East Houston Street Ground Storage Tank Rehabilitation
Solicitation Number: CO-00651
Job No.: 22-0106

ADDENDUM 4
June 1, 2023

RESPONSES TO QUESTIONS

DRAWING NO.
C2

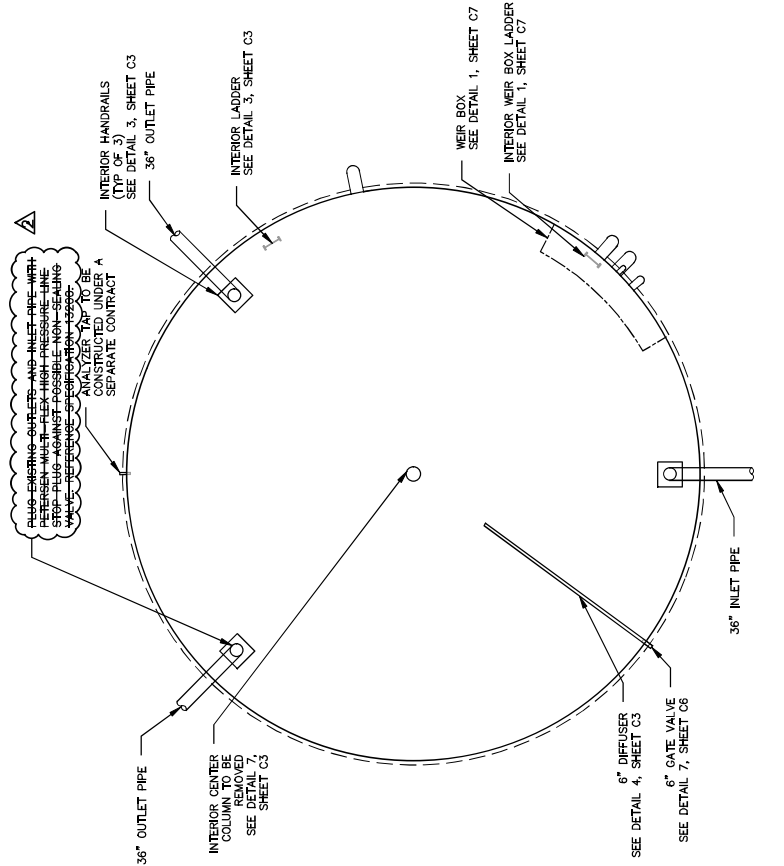
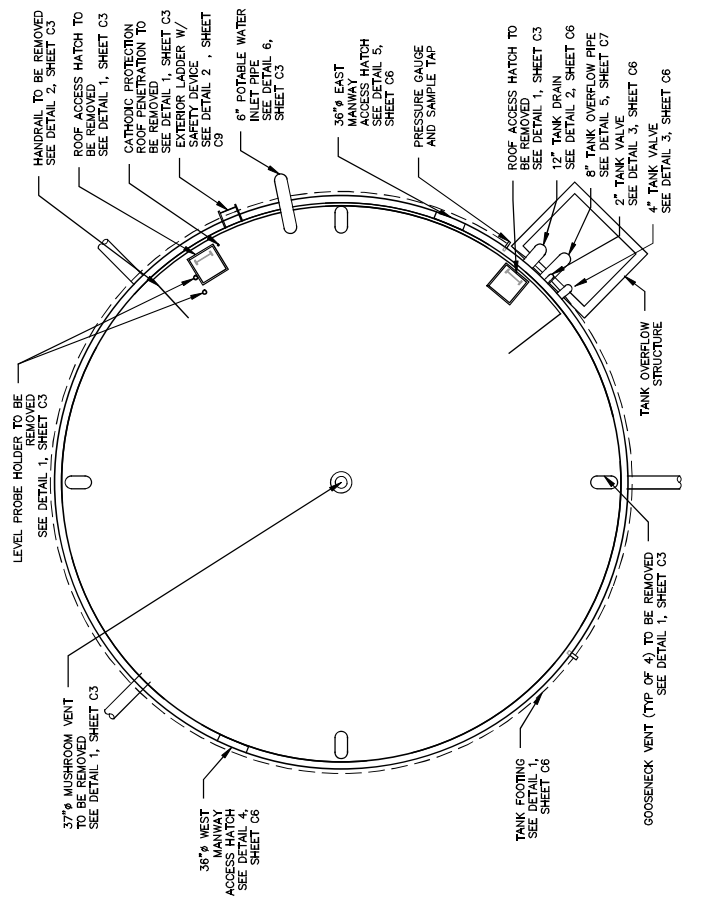
1. **Sheet C2 – Existing Ground Storage Tank Detail (Sheet 2 of 2)**
Remove and replace in its entirety with the attached sheet C2 – Existing Ground Storage Tank Detail (Sheet 2 of 2)
2. **Sheet C5 – Hatch & Platform Details**
Remove and replace in its entirety with the attached sheet C5 – Hatch & Platform Details.
3. **Sheet C10 – General Details (Sheet 5 of 6)**
Remove and replace in its entirety with the attached sheet C10 – General Details (Sheet 5 of 6).

DRAWING NO.
C10

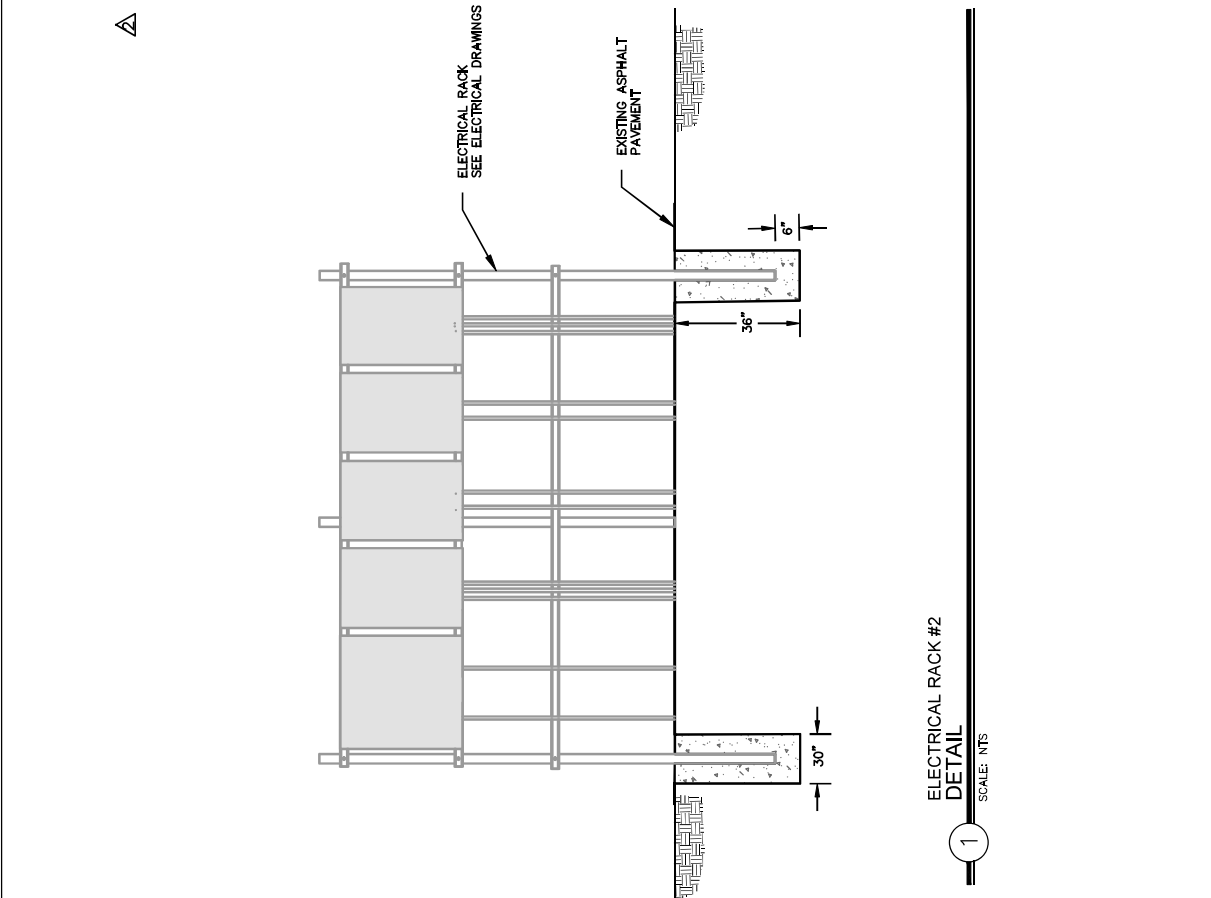
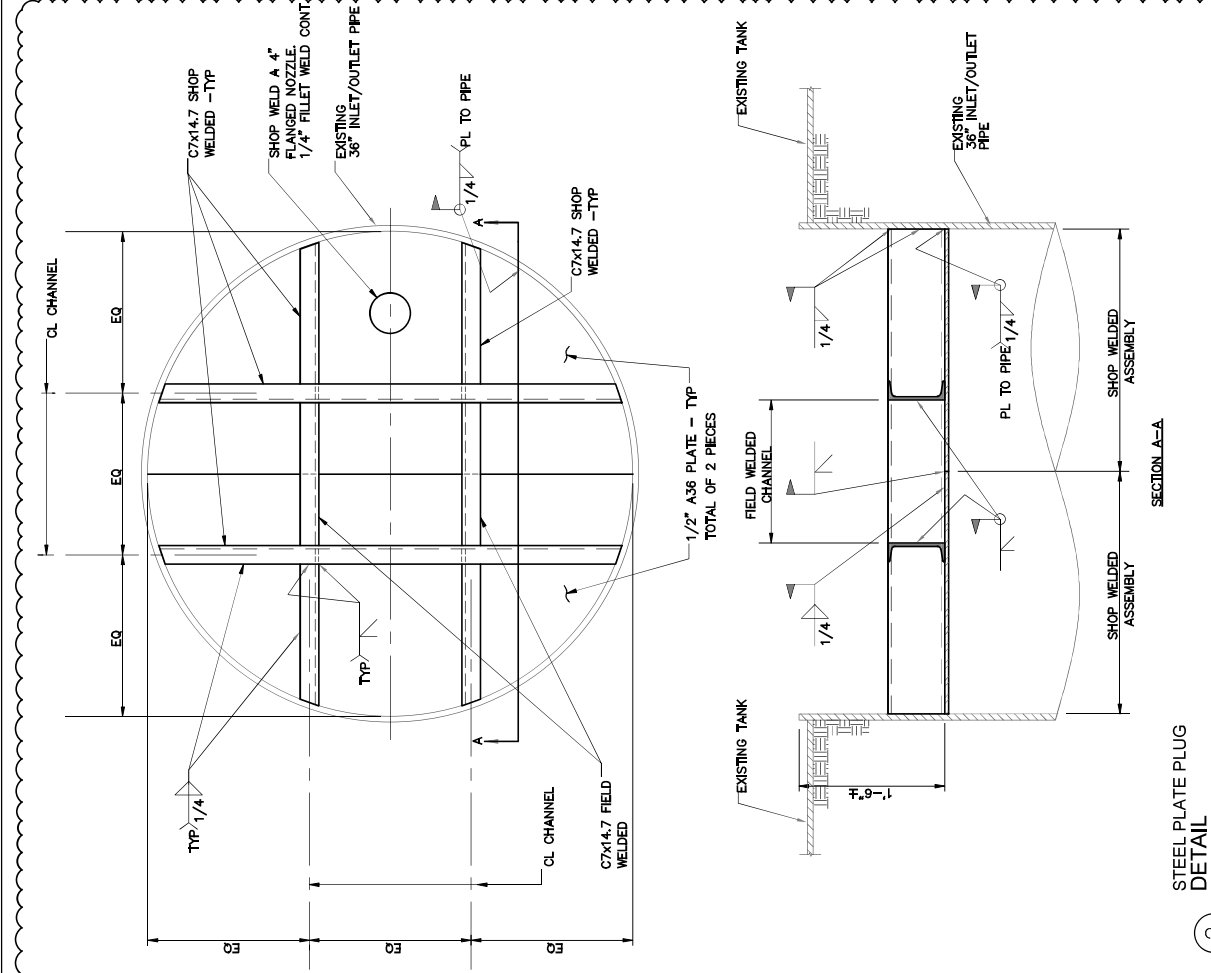
- 24. Question:** Confirm that there is no concrete pad required for the electrical rack and only piers for the posts will be required.
Response: No concrete pad is required for the electrical rack. Refer to Detail 1 on Sheet C10.
